Access Compliance Report

Public Rights-of-Way

(Curb Ramps)

Intersection ID: N/A	Main Street: PERIWINKLE_HILL_CT	Cross Street: N/A	Location: N
ADA ID: 87C020C60C21	Ramp Type: Perp	Initial Pass/Fail: Pass	Overall Compliance: No
Severity Score: 0.25			
Codes/Mitigation Info/Possible Solution		Field Measurements/Component Compliance

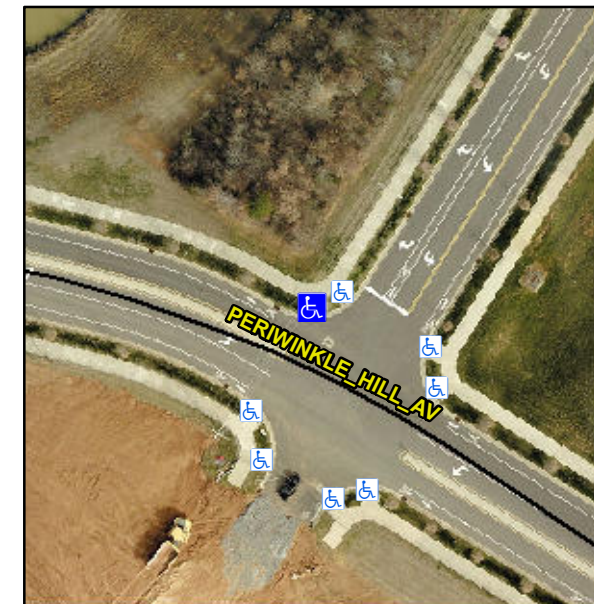
Not Found, R305.2

Remove & Replace Entire Ramp.
